Recall Bulletin 230516REV

RECALL BULLETIN: 230516REV	The purpose of this Recall Service Bulletin is to inform REV Recreation Group dealers of the need to inspect and replace the Lippert tow hitch receiver on certain model year 2020-2024 Fleetwood brand Bounder, Southwind and Holiday Rambler brand Vacationer models C, K, GL, and P. A list of affected motorhome serial numbers appear at the end of this Bulletin. CONDITION: On motorhomes affected by this recall campaign, the Lippert tow hitch receiver may become damaged when under stress by consumer added aftermarket appliances such as a drop hitch or by overloading of the RV. These related factors may increase leverage stresses on the hitch and/or cause the hitch to hit the pavement. A damaged tow hitch may cause the receiver portion of the hitch to separate from the hitch cross tube resulting in separation of the tow vehicle from the coach. DEALER CORRECTIVE ACTION: Follow the attached repair bulletin to inspect and replace the Lippert brand hitch that was used on vehicles built between Oct 2019 and May 2023. ATTENTION SERVICE, WARRANTY AND PARTS MANAGERS: All prior Authorization Approvals must go through REV RV Dealer Technical Sup

Figure 2

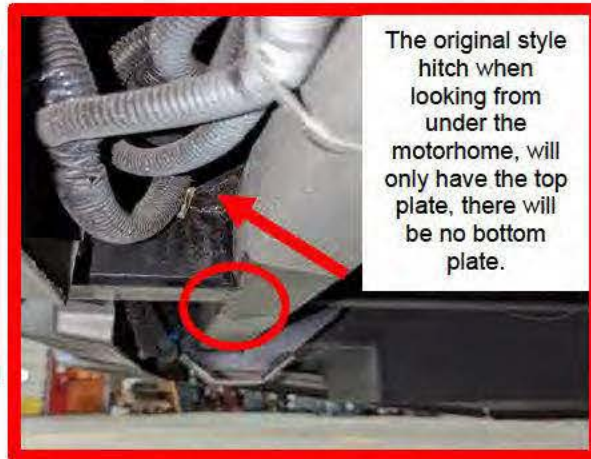
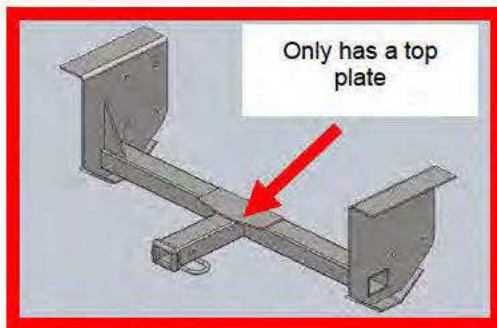
The original hitch installed will only have the top plate (See Figure 2). If this style is found, the hitch is required to be replaced with a new style hitch. **Take a photo and submit a claim using flat rate code 6313 12 Inspected/Defective/Replaced. Order replacement kit 10885526 (Must have UIN/VIN) to order kit.**

Figure 3

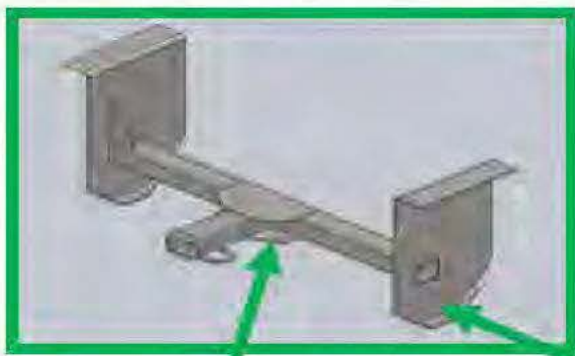
The new style hitch will have a top and bottom plate on the crossmember (See Figure 3). The new style hitch was only installed on units being built beginning April 2023, but verification will still be required. If the hitch looks like this, it will **not** need to be replaced.

Key difference is the additional bottom plate, and the skid plates are lower.

STOP: Take a photo and submit a claim using flat rate code 6313 11 Inspected/Not Involved in Recall as this hitch does not apply to this recall.
